15 July, 2012

Dear County Commissioners,

2003 air photo of Maclay Bridge (north to right of photo)

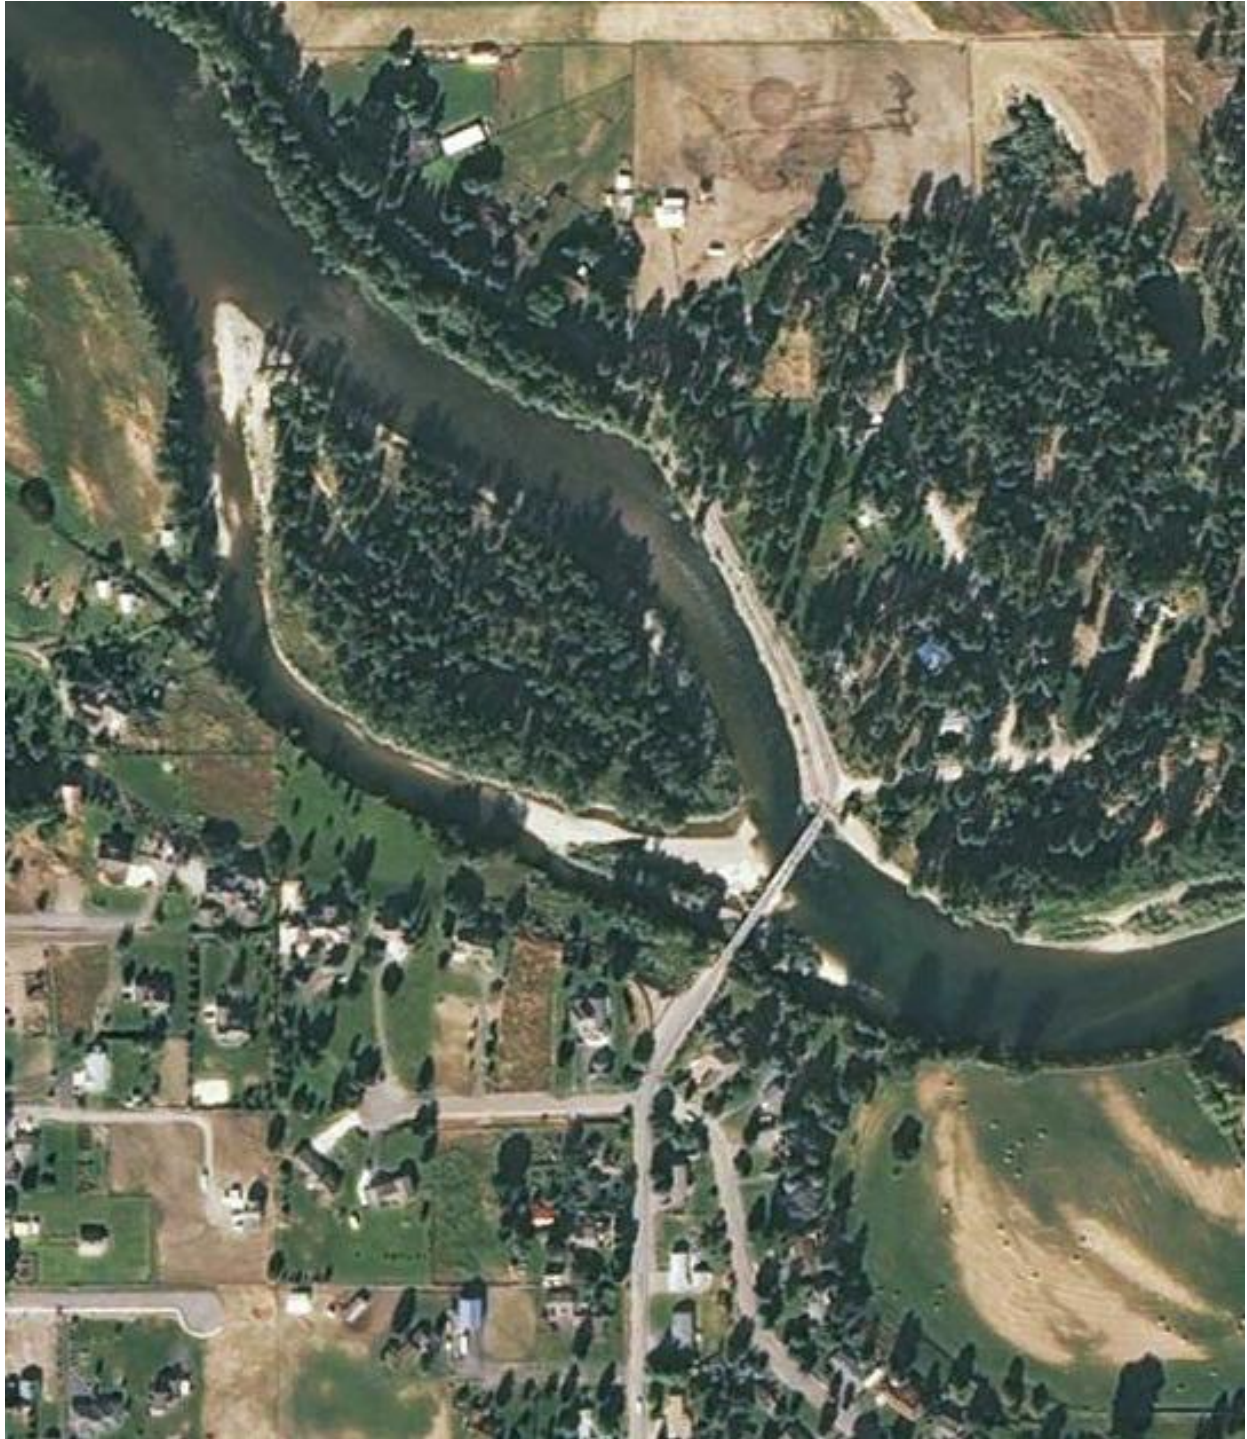
If you compare the 1935 photo to the 2011 photo, you can see just downstream of the west bridge abutment over time there has been significant erosion and loss of bank material for at least 100 to 200 feet. If you visit the site, especially during high flow periods, you can see the bank erosion appears to be related to a large whirlpool that developed under the main bridge span. The whirlpool also has created a deeply-scoured hole in the channel just under and downstream of the bridge.

The bridge's constriction of the river has somewhat slowed the water flow upstream of the bridge and may be causing the river to drop sediment there, adding to the sand bars and growth of the large island's north end. Again, a comparison of the 1935 and 2011 photos shows over time since the bridge was installed, the island and sandbars have grown from just upstream of the bridge in 1935, to at present where they extend under the bridge and downstream of it, particularly on the east side of the channel. In 1935, the center pier of the bridge was in the center of the river channel. At present, it is no longer in mid-river, rather now it is mostly surrounded by a long semi-permanent sand bar. The west main channel of the river appears to have been reduced in curvature (ie straightened) by River Pines Rd., which may be directing the river flow like a levee.
